**UNITED STATES DEPARTMENT OF COMMERCE
Patent and Trademark Office**

09/121,702 07/24/98 BECK

Office Action Summary	Application No.	Applicant(s)	
	09/121,702	Beck et al.	
	Examiner	Art Unit	
	FORD	3743

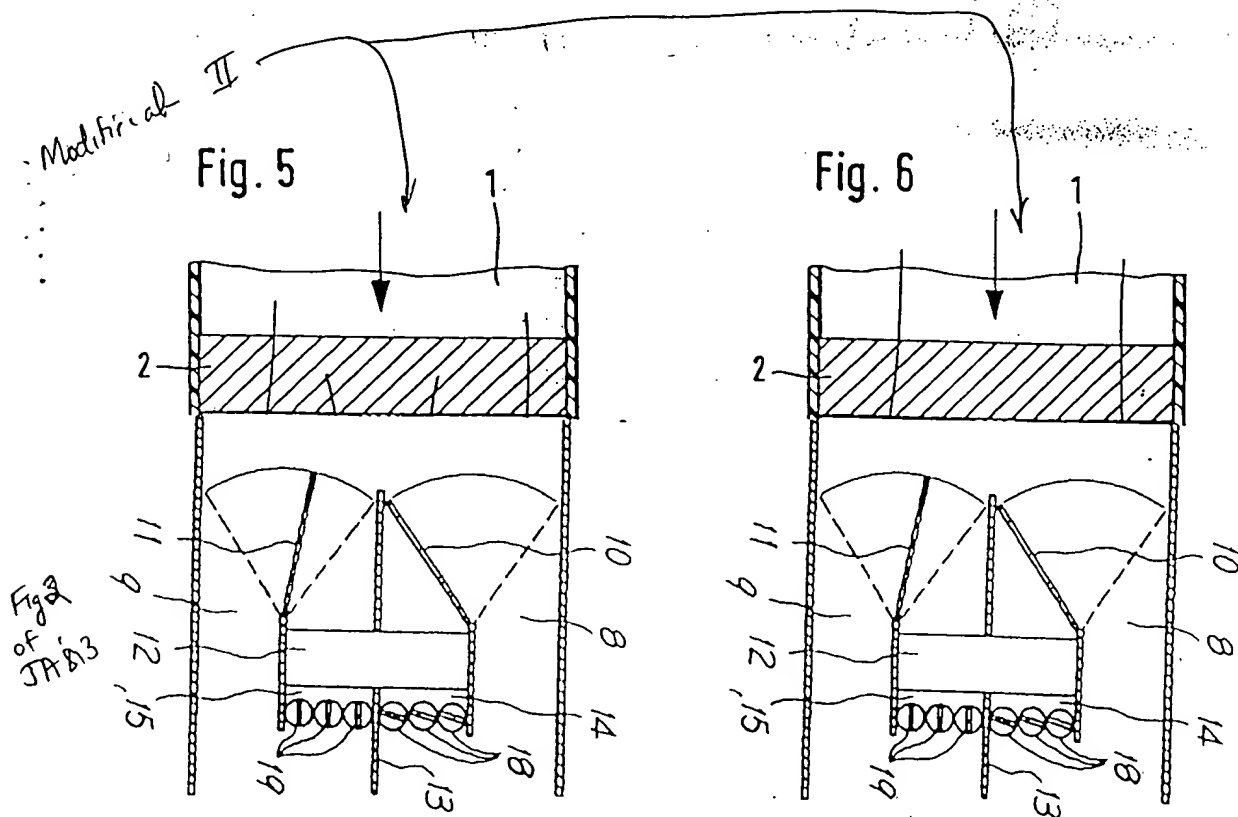
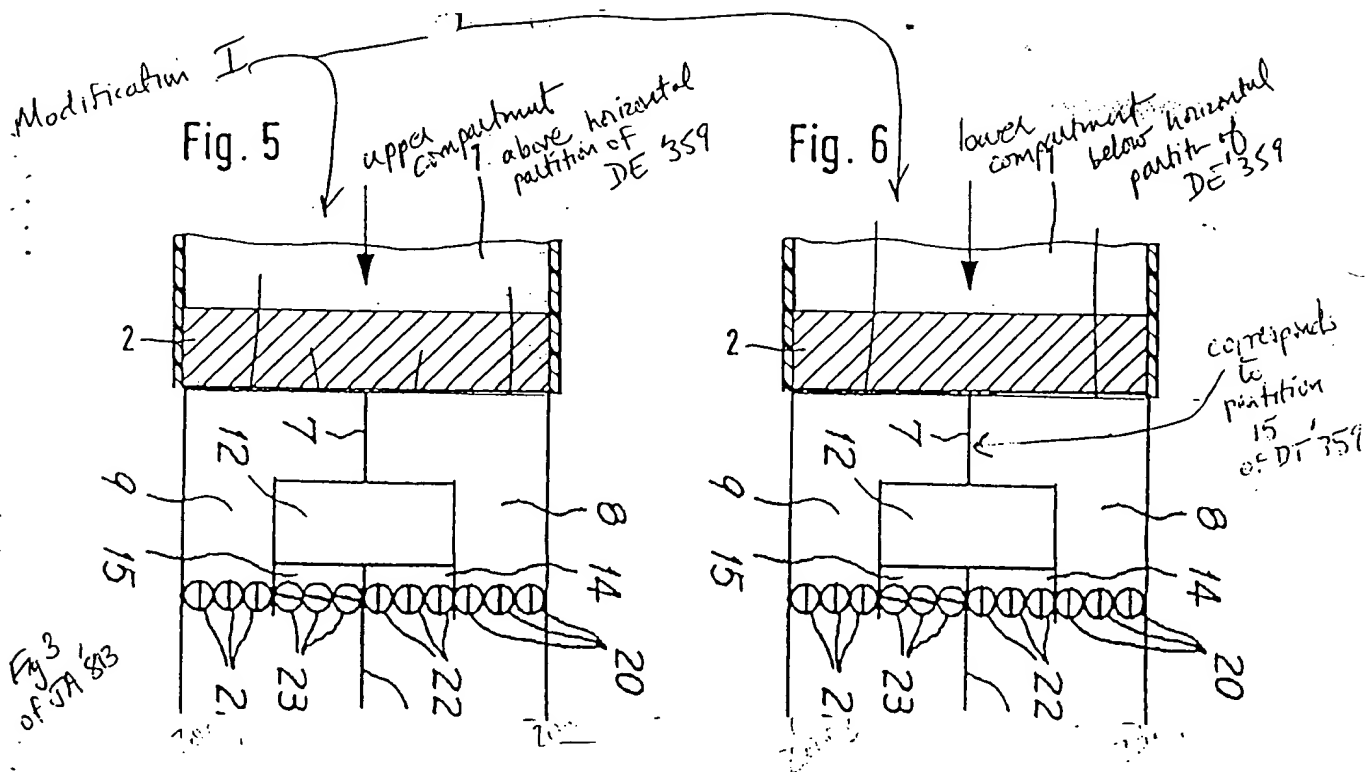
Claims 1 and 7 are rejected under 35 U.S.C. 103(a) as being unpatentable over the combined teachings of DT 35143~~7~~59 and JA 58-136813.

Figures 4-6 of DT '359 disclose a four zone system downstream of a split heater 3 and 4. Cold air bypass flaps 7, 8, 7' and 8' close off four cold air bypasses. Air mix dampers 5 and 6 in both figures 5 and 6 control cold/hot air mix ratios. To have modified DT '359 with either of the heater/bypass configurations taught by JA '813 to permit the use of a single heater core rather than the split type shown by DT '359 would have been obvious to one of ordinary skill in the art. The proposed modifications are shown pictorially on the next page.
